TJERNLUND PRODUCTS, INC.

CONVERSION TIPS FOR OLD HSUL & HST SERIES POWER VENTERS

IMPORTANT!!! UC1 BOARD VERSION X.06 UPDATES

HSUL-Series J-Box

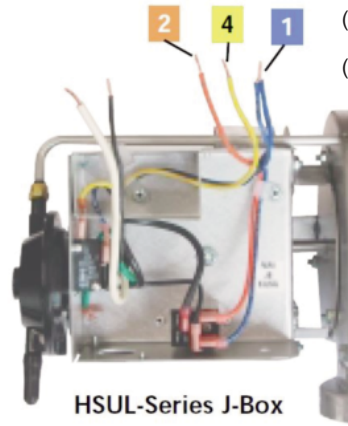
Reconnect to UC1 Terminal #'s.

- (UC1 Terminal 2) = HSUL Orange Wire
- (UC1 Terminal 4) = HSUL Yellow Wire
- (UC1 Terminal 1) = HSUL Blue Wires

X.06 VERSION UC1 BOARD FEATURES

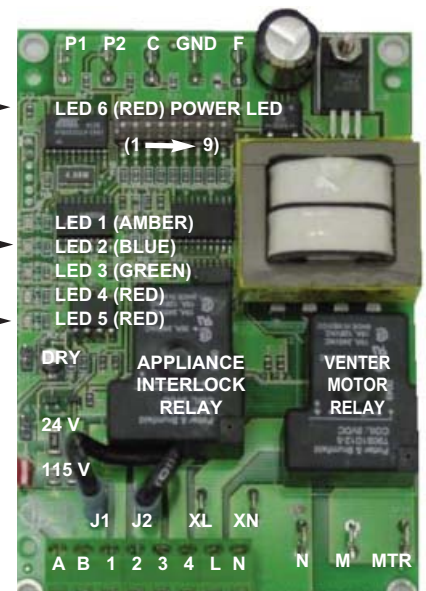
If replacing an existing Power Venter or UC1 that includes an X.02 or X.04 version of a UC1 board, the LED lights and sequencing have changed as outlined in this UC1 Board Version X.06 Update notice. See additional recommendations on back page for model specific information if replacing an existing Power Venter or UC1 Board.

A new #6 power LED

Constant red when 115 VAC is supplied to L & N.

A new color for the #2 LED

Constant blue when fan prover safety circuit is closed.

A revised #5 LED

With no call for heat present, flashes 3 seconds on / 3 seconds off if microcontroller is working properly.

New LED # 6 RED
 115V power supplied to UC1 L & N terminals

LED # 2 now BLUE
 (previously GREEN)

LED # 5 RED With no call for heat, flashes 3 seconds on / 3 seconds off if microcontroller is working properly.
